Subject: FW: 22 Beach Road, Littlehampton.

I contact you further to the below, and a subsequent conversation with your colleague Juan who requested, on behalf of the planning department, a drawing showing the location of the window vents required for noise mitigation purposes, as per the below discussions with the EHO. As per the discussions below, the vents are provided for habitable rooms for Flat 1 and for habitable rooms facing Beach Road for Flats 2 & 3.

I write further to the client providing me with your feedback on the AASL acoustic report dated 6th June 2019 for the above site.

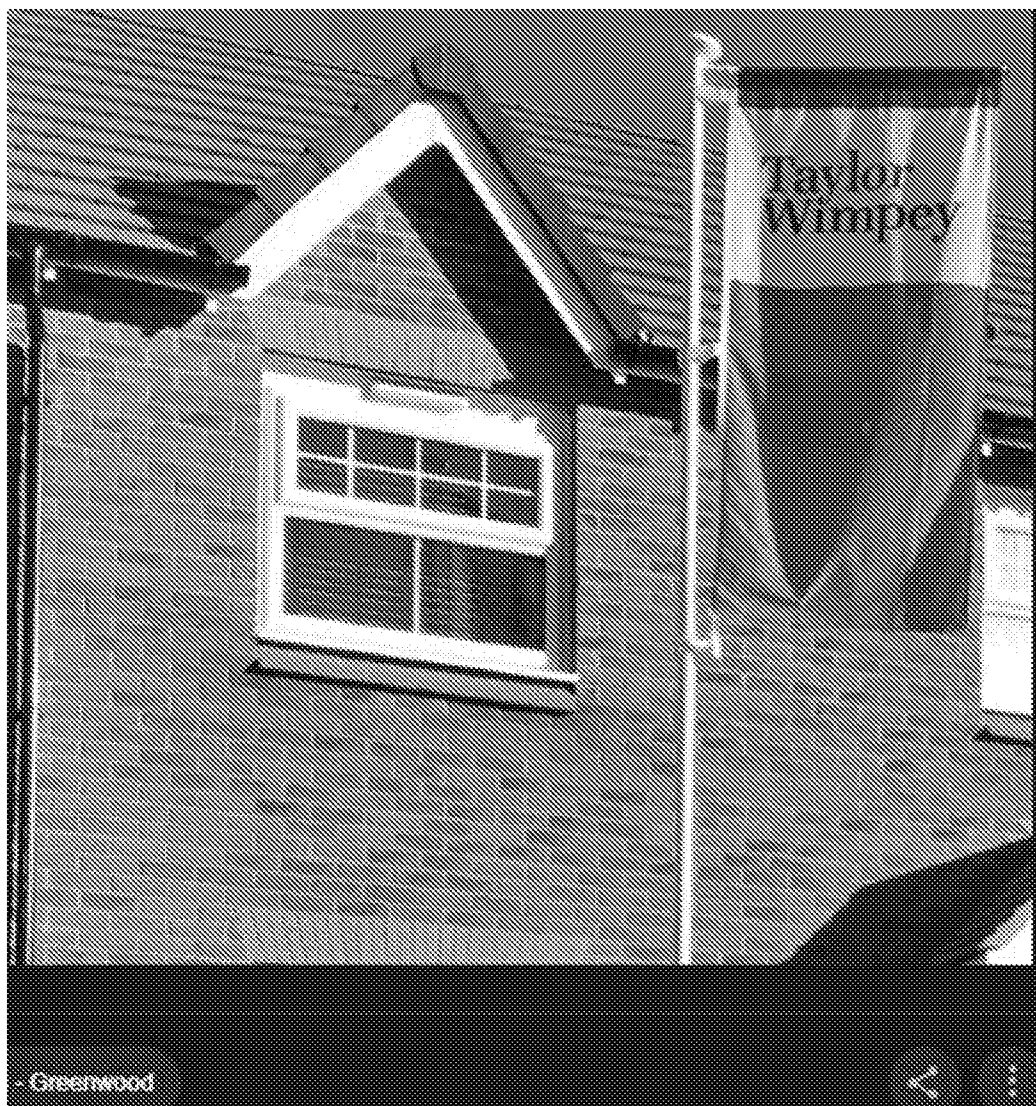
Before the applicant's noise consultants finalise their report in line with the discussions below with Carol Reynolds; as per below, can I get your confirmation that the proposed window acoustic vent (Greenwood 5000EA) shown on the attached specification sheet, required in relation to the noise mitigation discussed below, would be acceptable in terms of external appearance of the building please?

For reference, please see photo below of this vent installed to a window. As you can see the vent would have a negligible impact to the external appearance of the building and is arguably de minimis and does not require planning permission in itself.

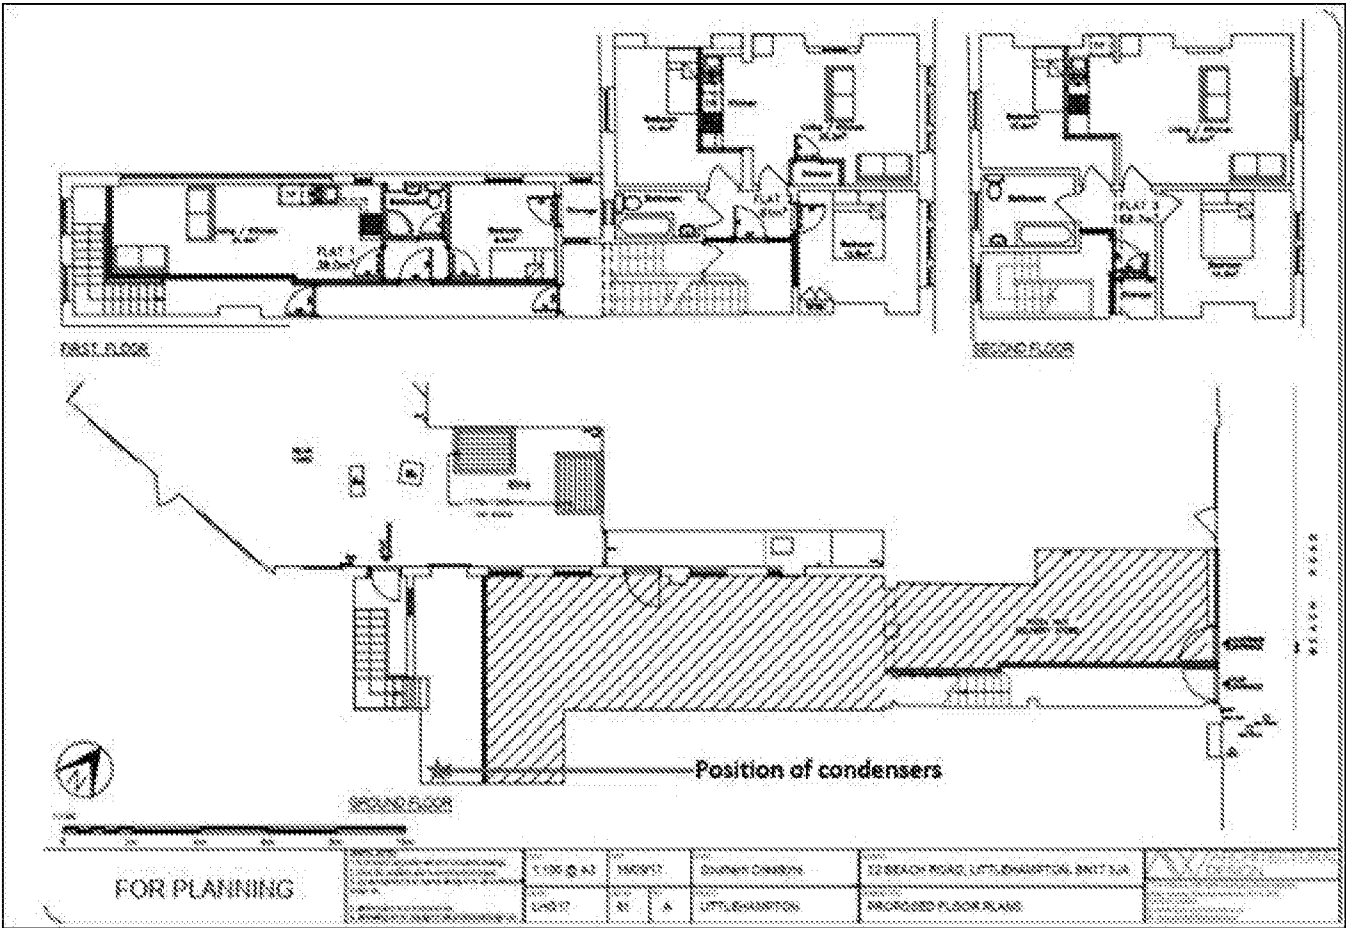
The condensers were previously located below the bedroom window but have since been relocated to inside the rear garage unit at the very rear of Flat 1, outside the demise of the flat.

The condensers are mounted on anti-vibration mounts on the ground floor. Both the garage and the pizza hut ceiling were soundproofed at the same time. The condenser positions inside the garage void are shown below.
